**V2500-A1/A5/D5 PROPULSION SYSTEMS SERVICE BULLETIN**

This document transmits Revision 1 to Service Bulletin EV2500-75-0063

**V2500-ENG-75-0063**

ENGINE - AIR - INTRODUCTION OF A HPT/LPT ACC AIR VALVE WITH NEW SLOTTED ENTRY TYPE  
ROD END ASSEMBLY

Fig 1

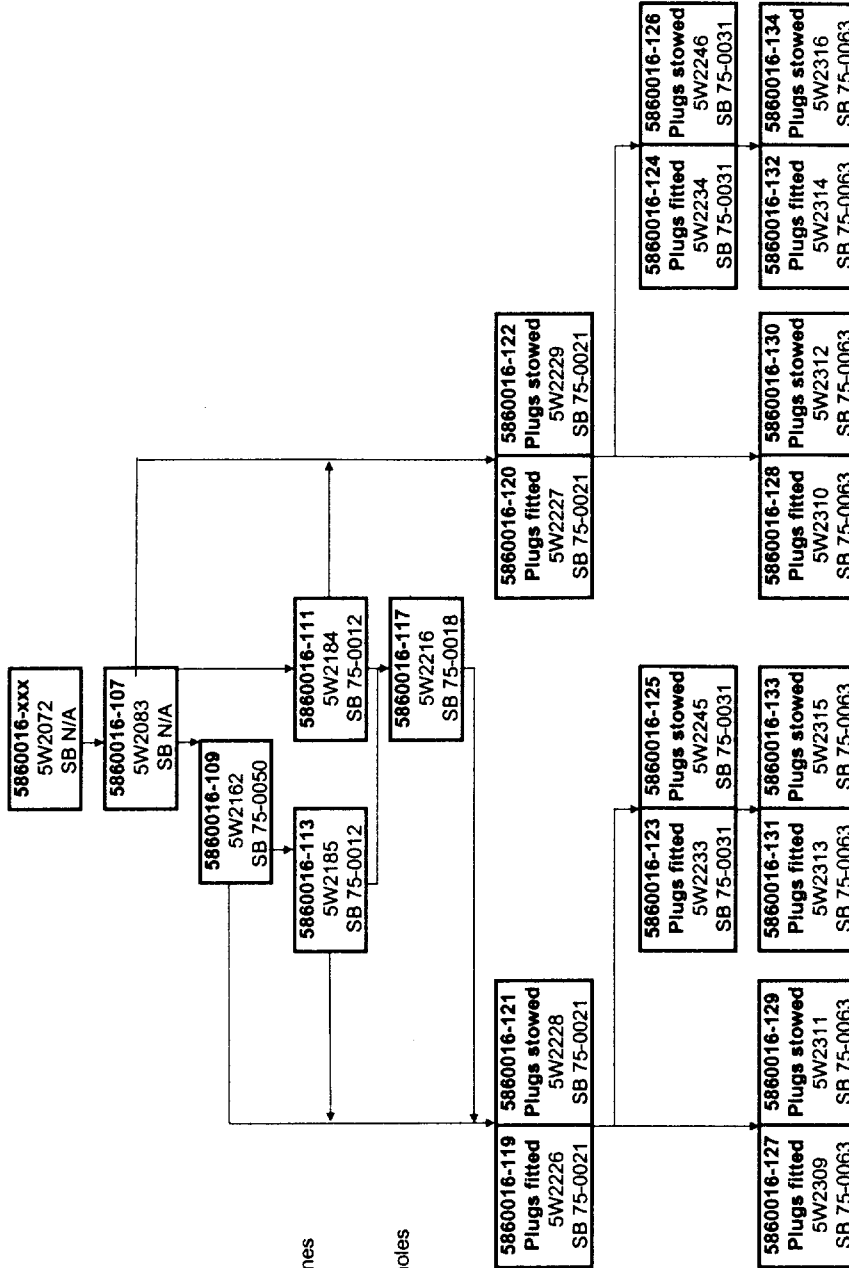
To revise illustrations to  
 incorporate a more user  
 friendly family tree

## MODIFICATION

Pre-DIS  
EC 88VJ313  
V0003Baseline  
EC 88VJ434  
V0014Strengthen ACC cambox  
EC 89VJ076 : V0107  
SB 75-0050Remove seal rings from vanes  
EC 89VJ133 : 9002  
SB 75-0012New single seal ring & air holes  
EC 90VJ005A : 9010  
SB 75-0018Plug plate with  
seal rings & air holes  
EC 90VJ005B : V0142  
SB 75-0021Anti-rotation bushing  
EC 91VJ056 : V0292  
SB 75-0031Slotted entry bearing  
EC 95VJ039 : V0362  
SB 75-0063

Family Tree - HPT/LPT ACC Air Valve for V2527-A5 and V2530-A5 Ref. Catalog Sequence  
No. 75-24-51 Fig. 01 Item 100 (Part No. 5860016)  
Fig 2

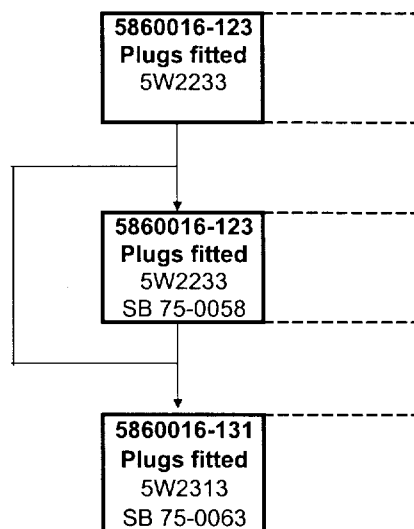
Controlled service use:  
Replacement rod end  
SB 75-0058

Slotted entry bearing  
EC 95VJ039 : V0362  
SB 75-0063

Figure 1

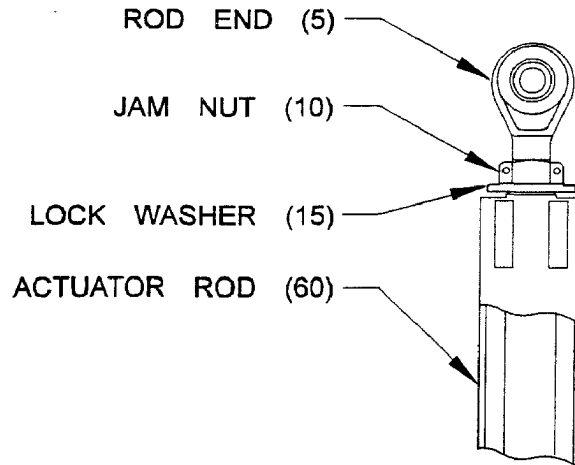
B. Assemble the valve with the new rod end assembly, P/N 5952015-101, according to CMM, ATA 75-24-51, ASSEMBLY section, and per the following instructions.

- (1) Install lock washer (15), jam nut (10), and rod end (5) into actuator rod (60). (See Figure 1)
- (2) Install the assembly aid, F80-0-50623, to the inlet side of the HPT body assembly (265).

Figure 2

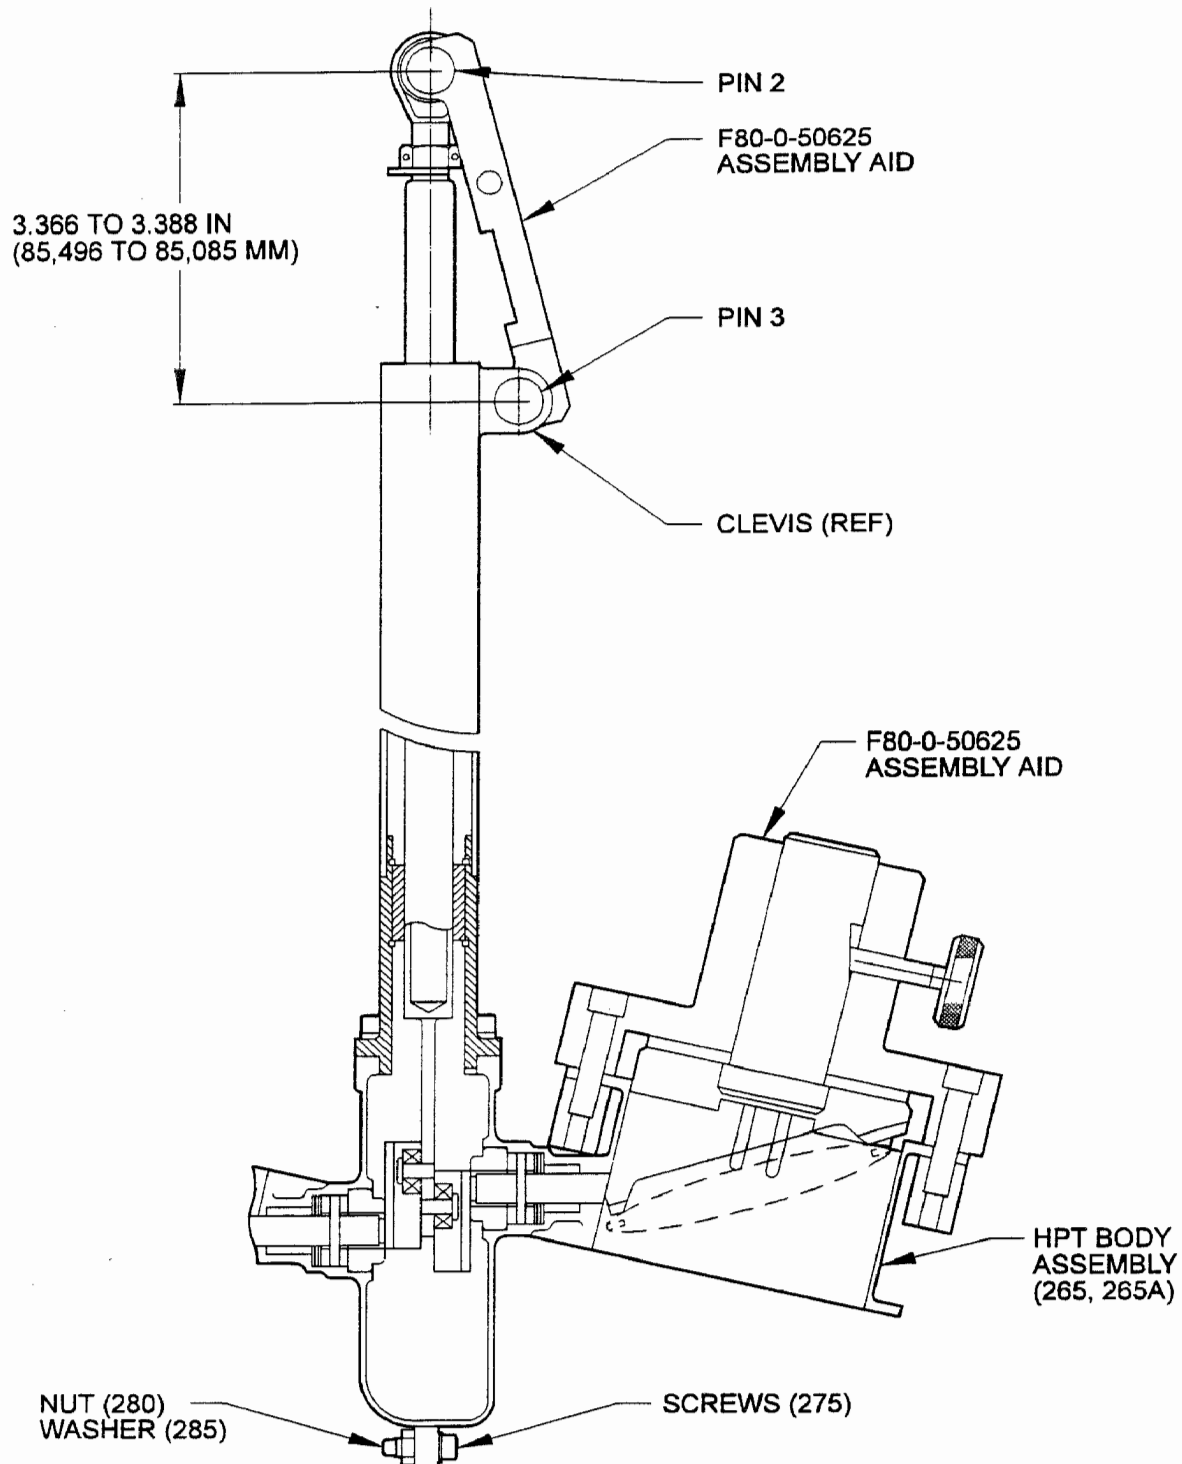
- (3) Adjust the HPT vane (110) and LPT vane (170) to an angle of 30°36', and clamp the vanes in position using thumbscrews.
- (4) Install the adjustment aid, F80-0-50625, onto the clevis end of the tube and fitting (20), using the pins supplied with the adjustment aid. (See Figure 2)
- (5) Adjust the rod end (5) to 3.366 to 3.388 inch (85,496 to 86,055 mm).
- (6) Make sure that the tang of the lock washer (15) is in the groove of the actuator rod assembly (60).
- (7) Tighten the jam nut (10) to a torque of 60 to 70 in-lb (6,78 to 7,91 N·m).
- (8) Lockwire the jam nut to the lock washer using lockwire, MS20995N20.
- (9) Remove the assembly aid, F80-0-50623, and the adjustment aid, F80-0-50625.

Figure 1

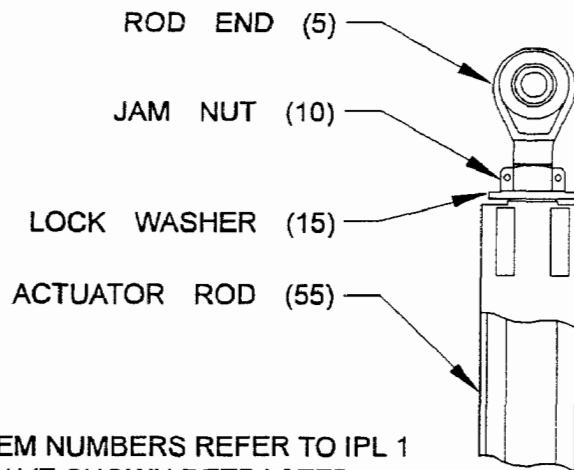
- B. Assemble the valve with the new rod end assembly, P/N 5952015-101, according to CMM, ATA 75-24-71, ASSEMBLY section, and per the following instructions.

- (1) Install the lock washer (15), jam nut (10), and rod end assembly (5) into the actuator rod assembly (55). (See Figure 1)
- (2) Install the assembly aid, F80-0-50623, onto the inlet side of the HPT body assembly (295).
- (3) Adjust the HPT vane (115) and LPT vane (215) to an angle of 30°6', and clamp the vanes in position using thumbscrews.

Figure 2

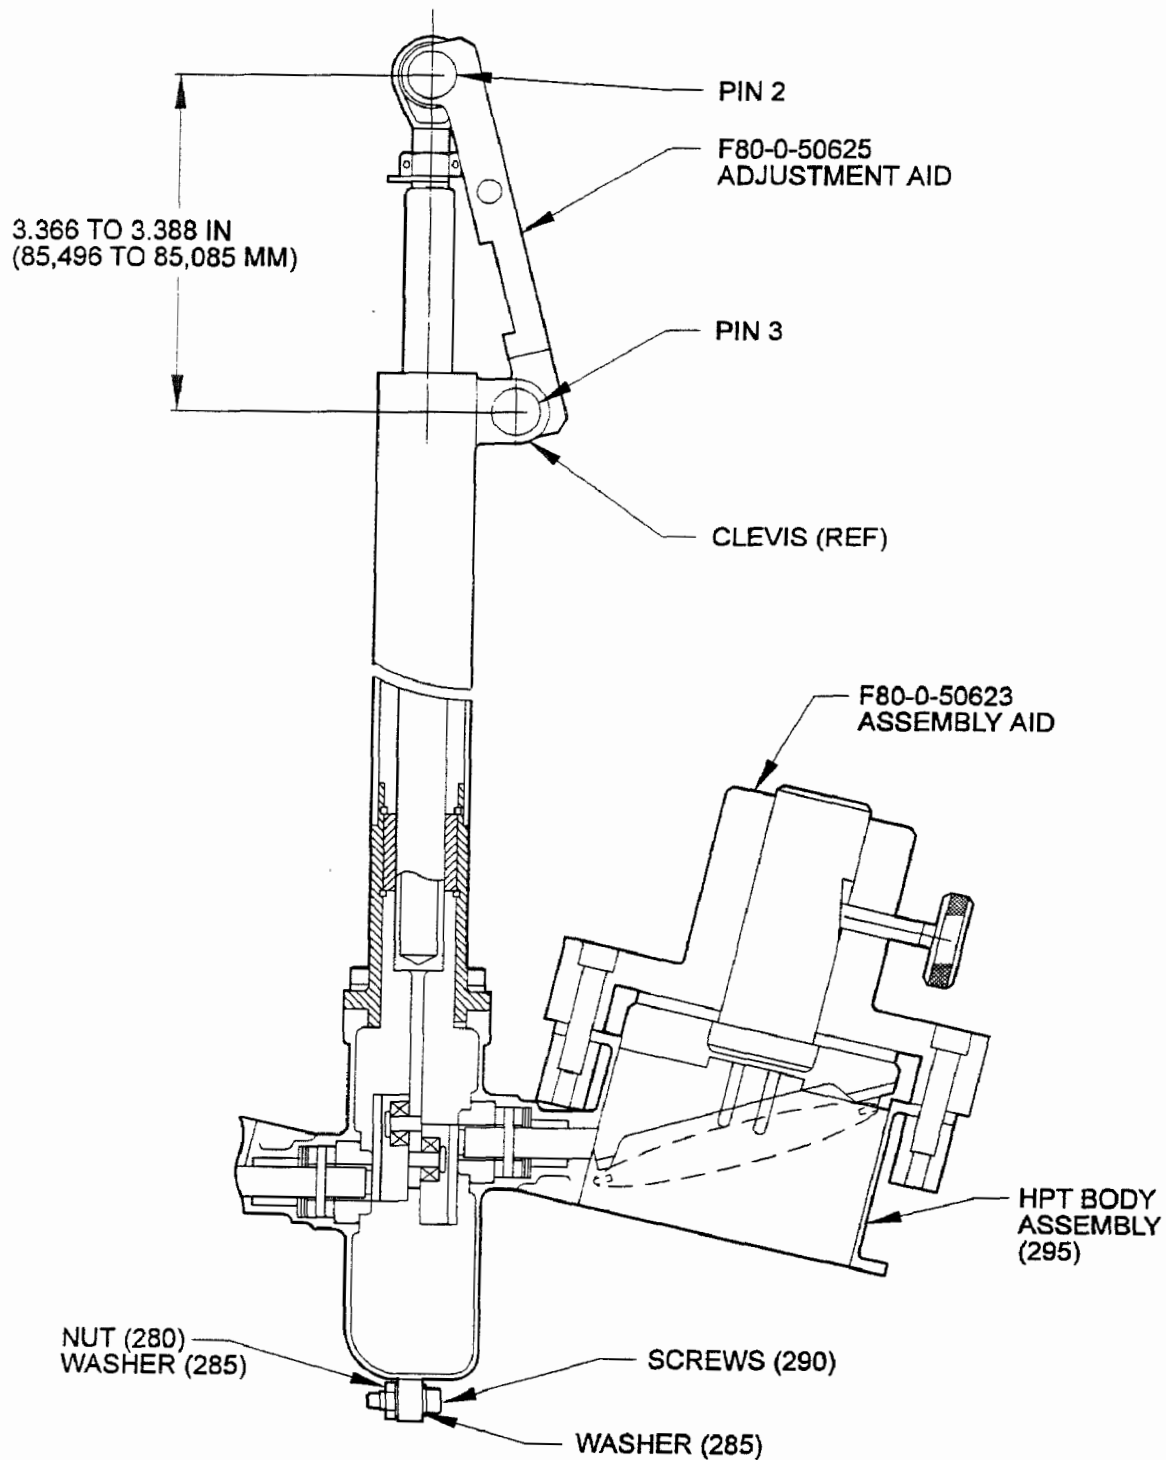
- (4) Install the adjustment aid, F80-0-50625, onto the clevis end of the tube and fitting assembly (20), using the pins supplied with the adjustment aid. (See Figure 2)

- (5) Adjust the rod end (5) to 3.366 to 3.388 inch (85,496 to 86,055 mm).
  - (6) Make sure that the tang of the lock washer (15) is in the groove of the actuator rod assembly (55).

- (7) Tighten the jam nut (10) to a torque of 60 to 70 in-lb (6,78 to 7,91 N·m).
  - (8) Lockwire the jam nut to the lock washer using lockwire, MS20995N20, per AS567, using a double-twist method.
